Permit No: 03-0390	Issue Date: JUN 17 2003	CBL: 040 C026001
-----------------------	-----------------------------------	---------------------

This is to certify that 75 York Street Llc /Benchmark
has permission to Tenant Fit Up to Office Space Modify Exterior, 450' ADDITION **JUN 17 2003**
AT 75 York St 040 C026001

To: Scott Simons From: Mike Nugent
Fax: 828-4656 Date: May 13, 2003
Phone: 772-4656 Pages: 1
Re: 75 York St. (040 C026)

Date: June 12, 2003
Project name/number: 75 York Street, LLC, SSA #02034.00
Re: Building Permit Questions
From: Stephen Fraser
To: Mike Nugent, City of Portland Building Department
Cc: Scott Simons, Paul Becker, Dave O'Connell, Jobfile 3.1

TITLE
SITE DETAILS

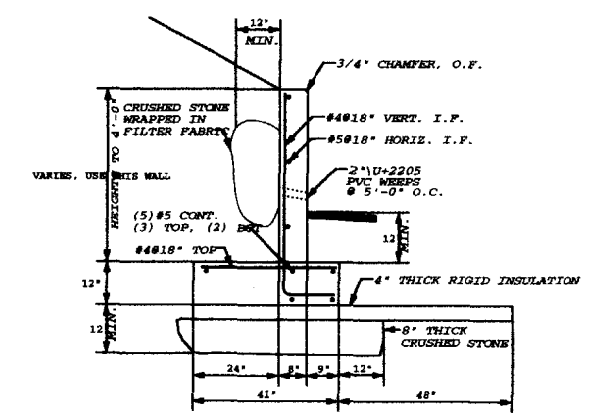
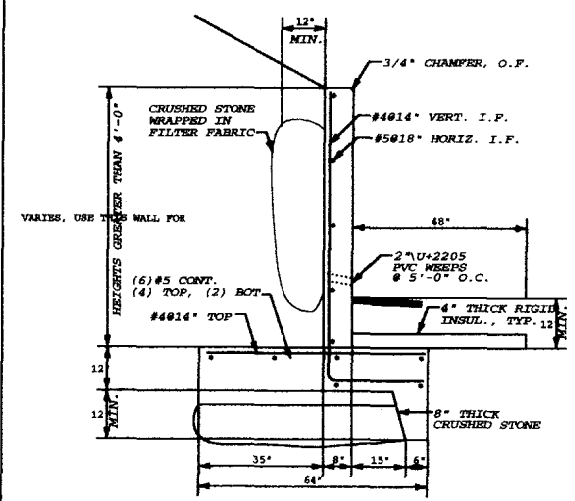
- 1) Guards on entryway "retaining wall" must be 42" w/ openings less than 4"

- 1) What are the potential uses for lease spaces?
- 2) Retaining wall will require a Guard (see Section 1825. 1999 BOCA Code)
- 3) A full size set of plans must be provided, the 11" x 17" are for archiving purposes.
- 4) All proposed guards must be 42 inches in height with openings less than 4 inches.
- 5) Roof loading must be calculated in accordance with Section 7.3 of ASCE 7 (Section 1608.3)
- 6) Stairways appear to have inconsistent ratings (less than 1 hour) if you use Wall type "B" on page A100
- 7) Pipe Rail must have code compliant balusters.

- 7) Again Section 1825.5 states an exception to guards. By installing a pipe rail it keeps pedestrians 2'-0" away from the edge. If you would like, we would be willing to add an additional intermediate horizontal bar @ 18" to prevent children from running under. We have used this detail before and believe it is acceptable under BOCA.

TITLE
**FIRST
 FLOOR PLAN**

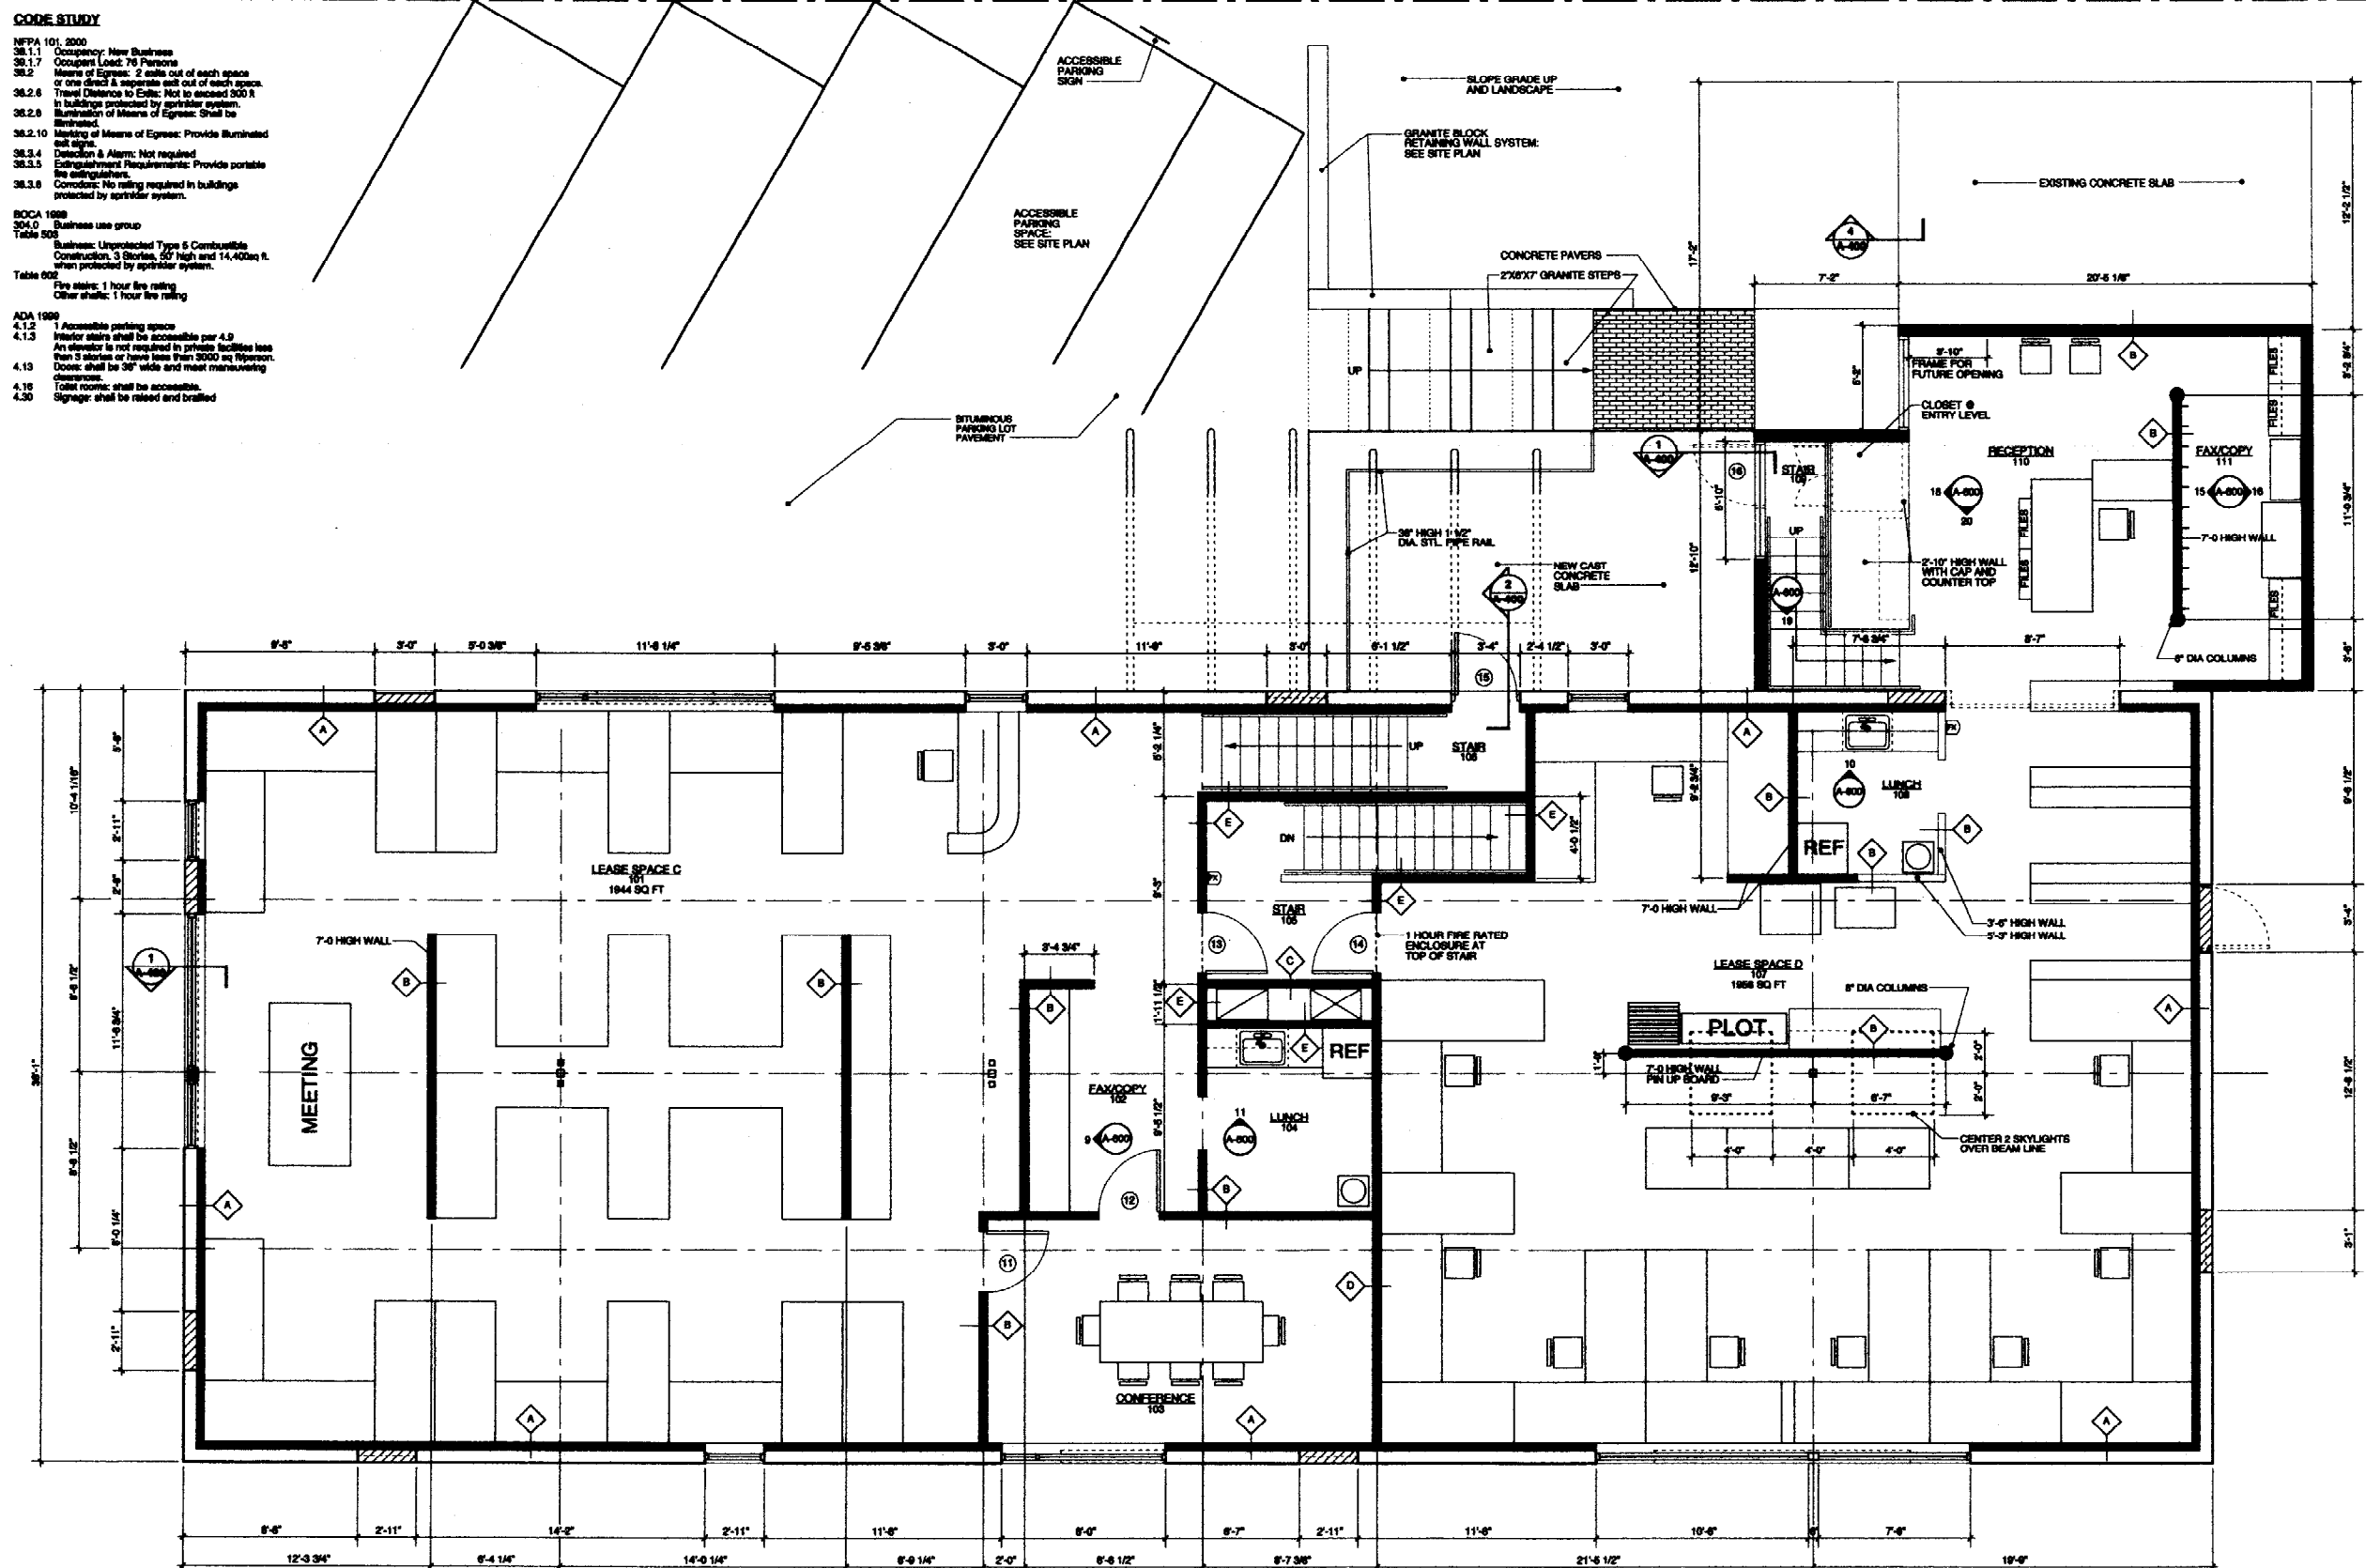
Entire exit access stairway must have a one hour fire rating.
New plans must be submitted reflecting these changes for review
